**PROPOSED COMMERCIAL
DEVELOPMENT**
PART OF LOT 19, CONCESSION 1
M.N. 517 PARIS ROAD
COUNTY OF BRANT

LANDSCAPE PLAN

DESIGN:	R.W.P.	SCALE:	1:250
DRAWN:	S.L.M.	JOB No:	9266
CHECKED:	R.W.P.	DWG. No:	9266-3
SHEET:	3 of 3		
DATE:	MAR. 9, 2017

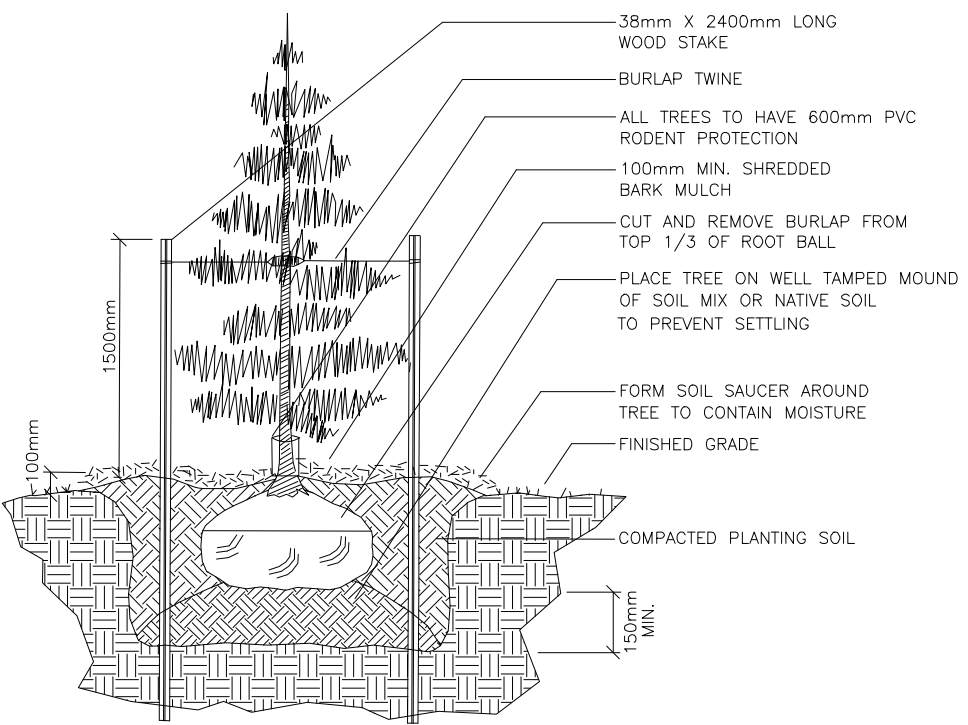
NOTE:
EXISTING 250mmØ WATERMAIN ALONG THE WEST SIDE OF OAK PARK ROAD, PROVIDES SERVING FOR THE SUBJECT LOTS. THE LOCATION OF THE CONNECTION AND DETAILS HAS NOT BEEN PROVIDED. ROAD RESTORATION ON OAK PARK ROAD WILL BE THE RESPONSIBILITY OF THE OWNER AND IS REQUESTED TO BE SHOWN ON THE PLAN, TO THE SATISFACTION OF THE COUNTY.
